Port of Seattle

REQUEST FOR BIDS RFB 2026-RCF

RENTAL CAR CONCESSIONS AT SEATTLE-TACOMA INTERNATIONAL AIRPORT

ADDENDUM #2

LEVEL 01 - PREFERRED SCHEME

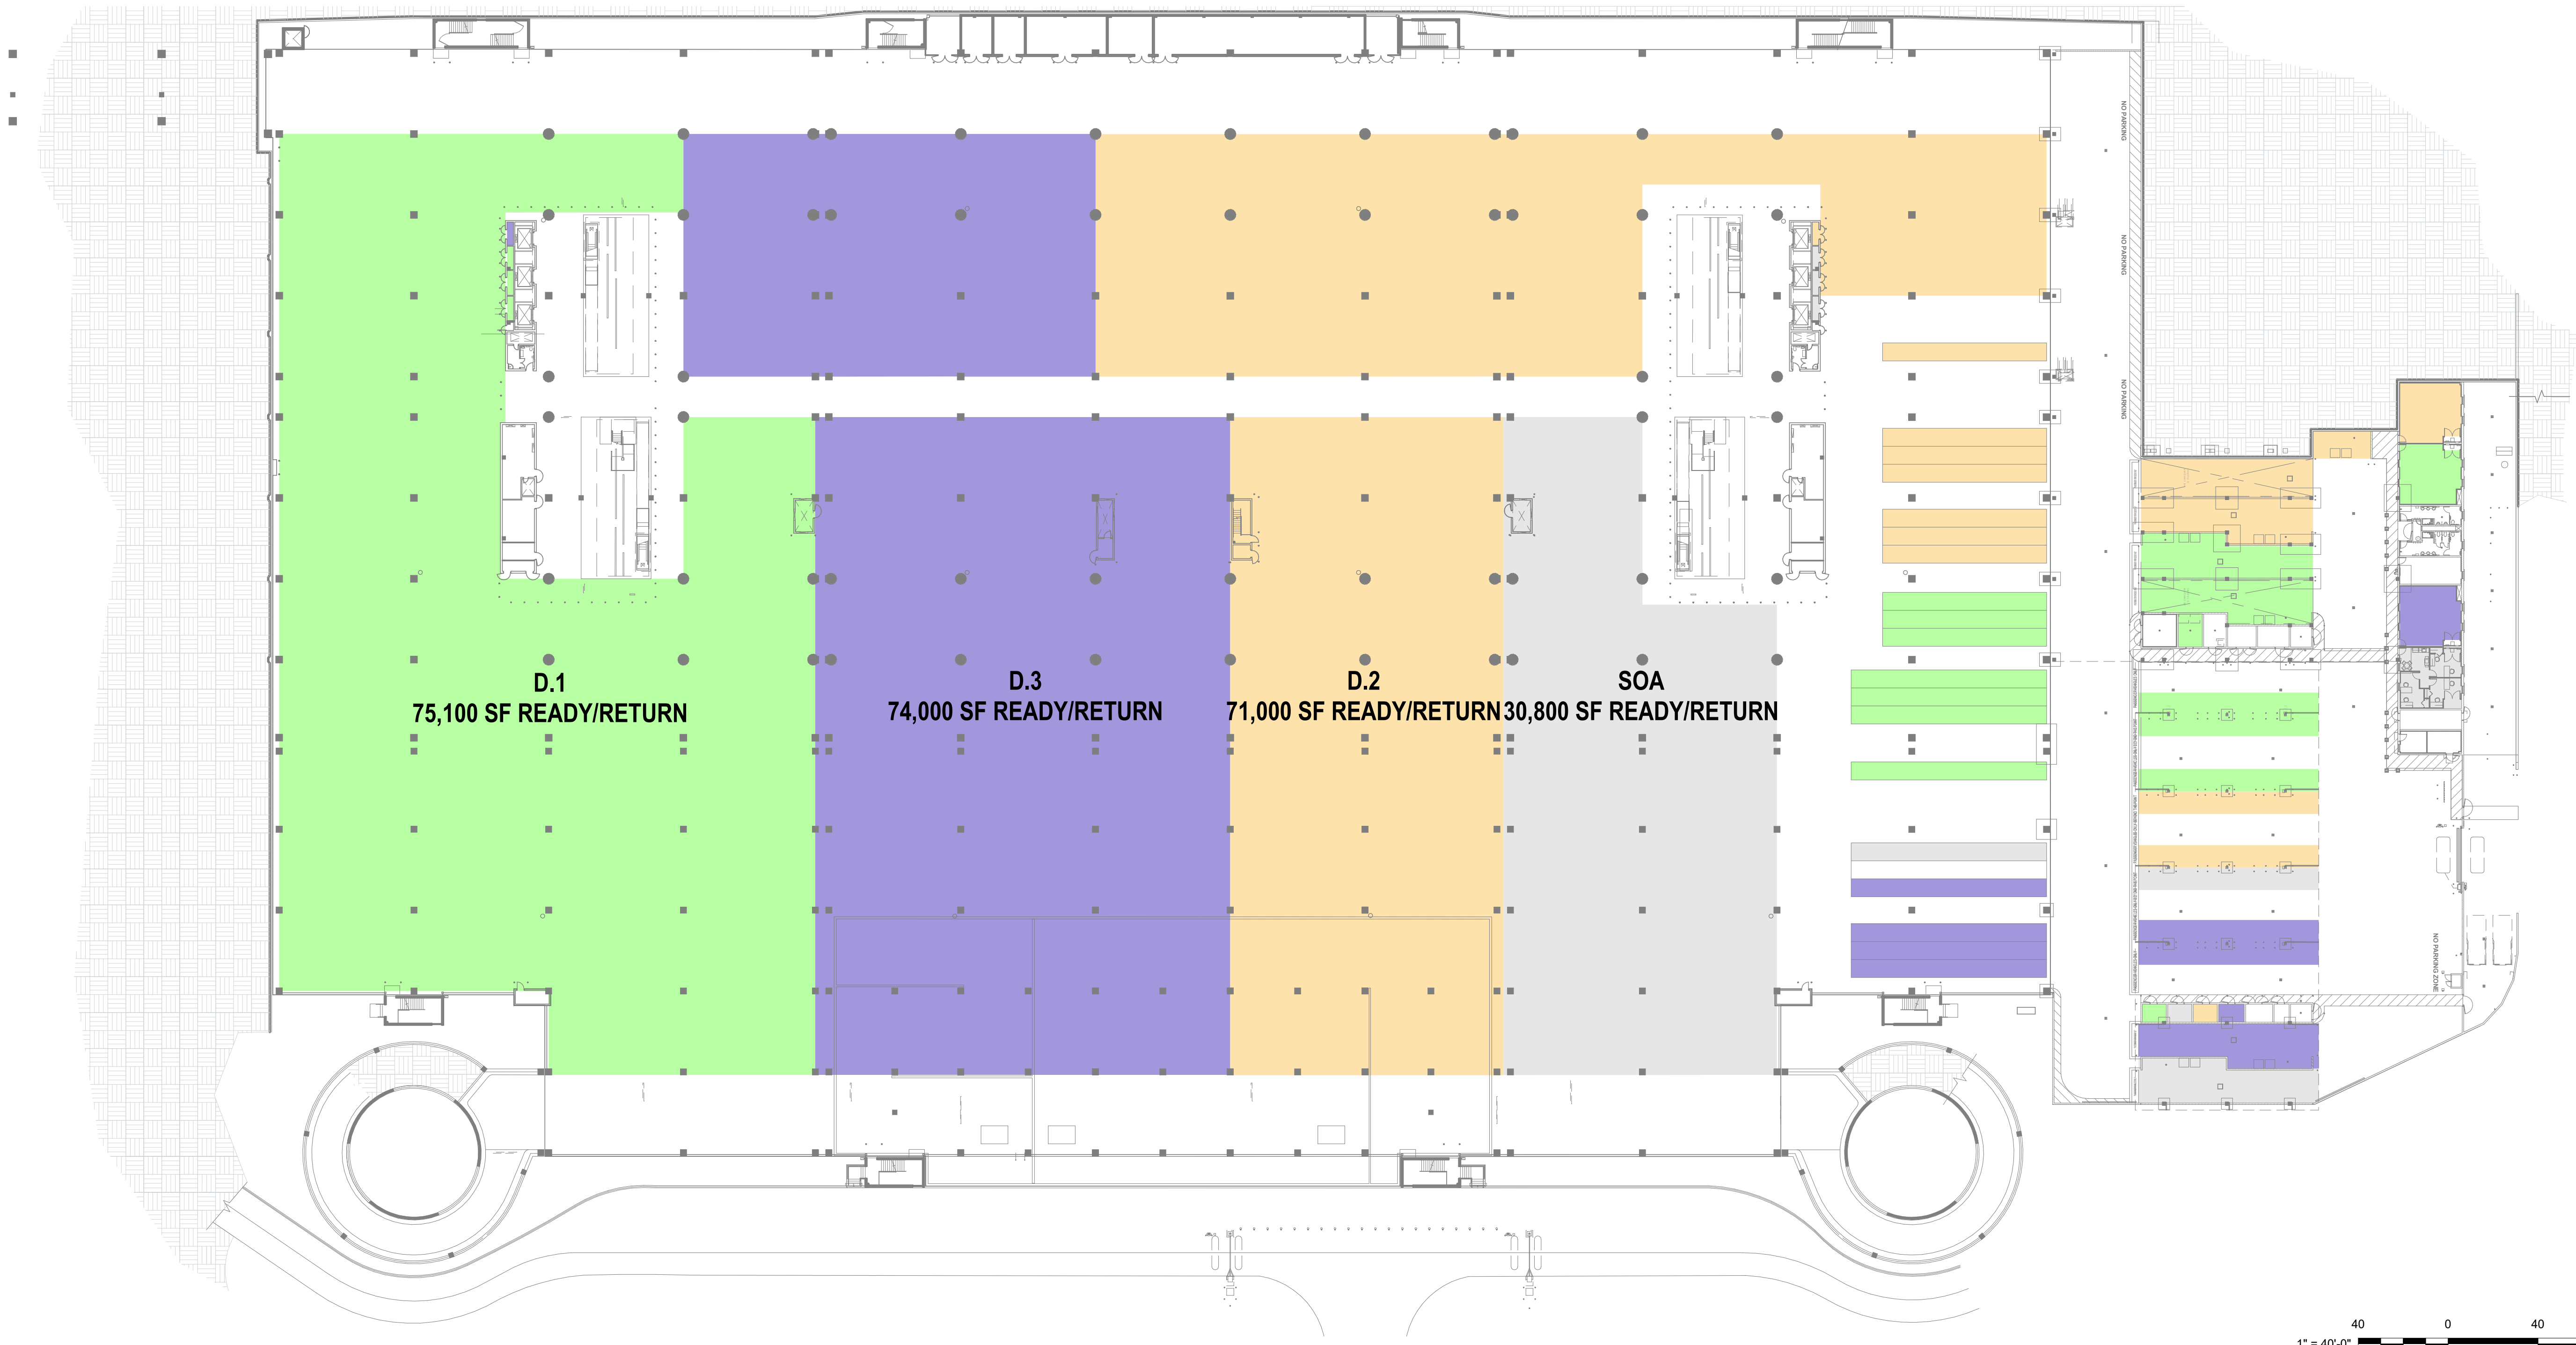
12. Question: The drawing appears to have exclusive use space outlined where there is a common drive lane, can you confirm? Please see the clouded area in the drawing.

Change to Exhibit A-2 (Floor 1 Operational Space)

Please see the following page for the replacement to Exhibit A-2 in the RFB.

a. **Port Response:** The Port will update Exhibit A to ensure common areas are not included in block allocations and square footage calculations. This will be made available in a future addendum.
